STAFF MEMORANDUM

Subject: SP2021-20 Ronald and Loreen Racicot, 21 Old Wilton Road, Tax Map 14 Lot 10. Public Hearing for a major site plan application to construct a 4,500 sf. warehouse and storage building and associated site improvements within the Industrial District.

DRAINAGE / STORMWATER MANAGEMENT:

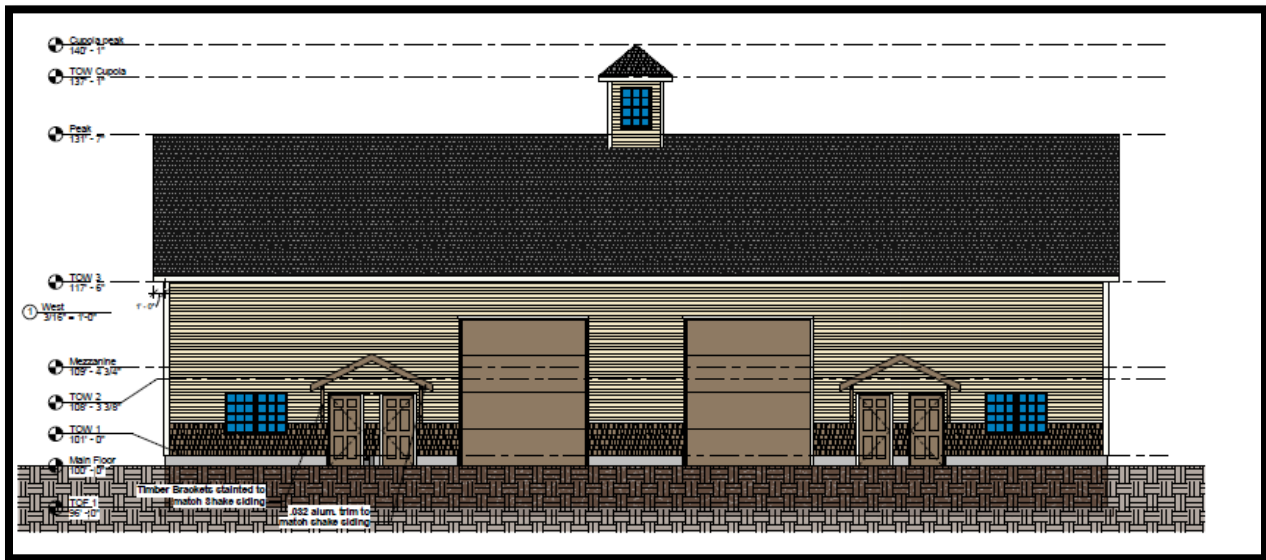
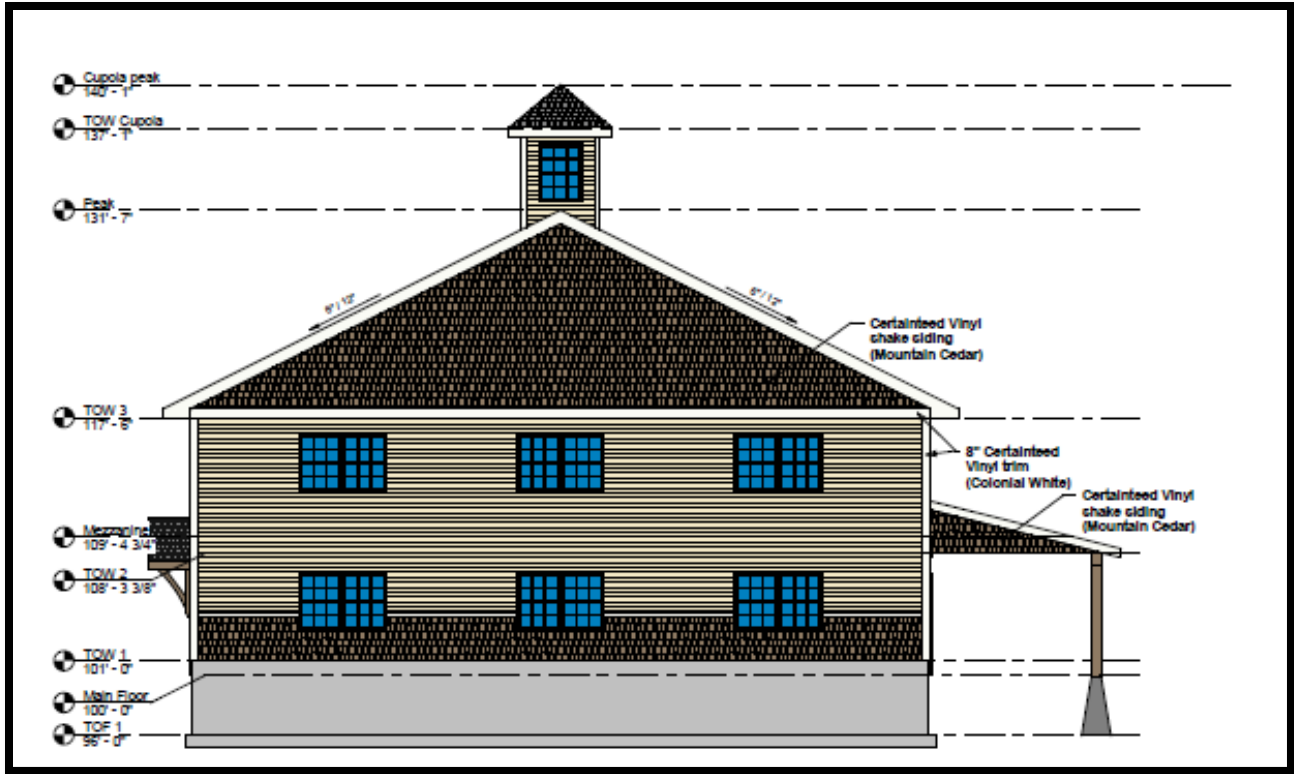
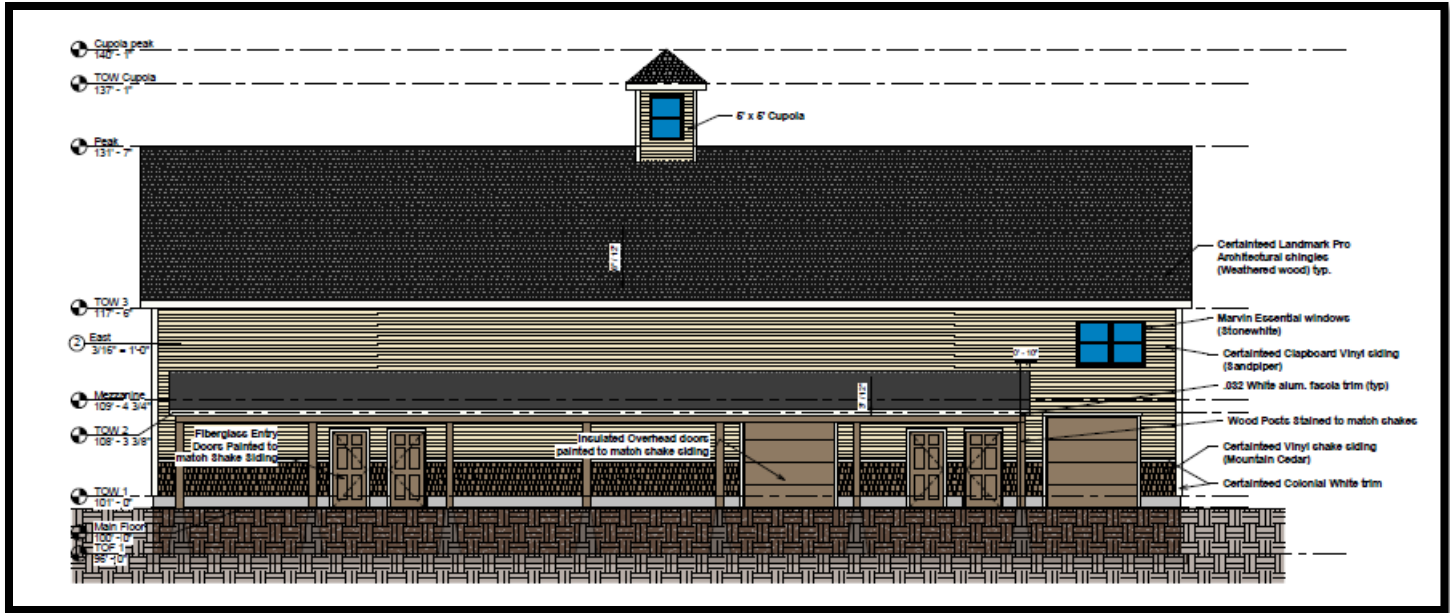
Stormwater and drainage associated with the industrial warehouse and paved areas will be managed through the construction and installation of a retention pond. The applicant submitted a stormwater permit application, which is currently under review. Please see comments below.

Stormwater Engineer: Comment was addressed. No further comments.
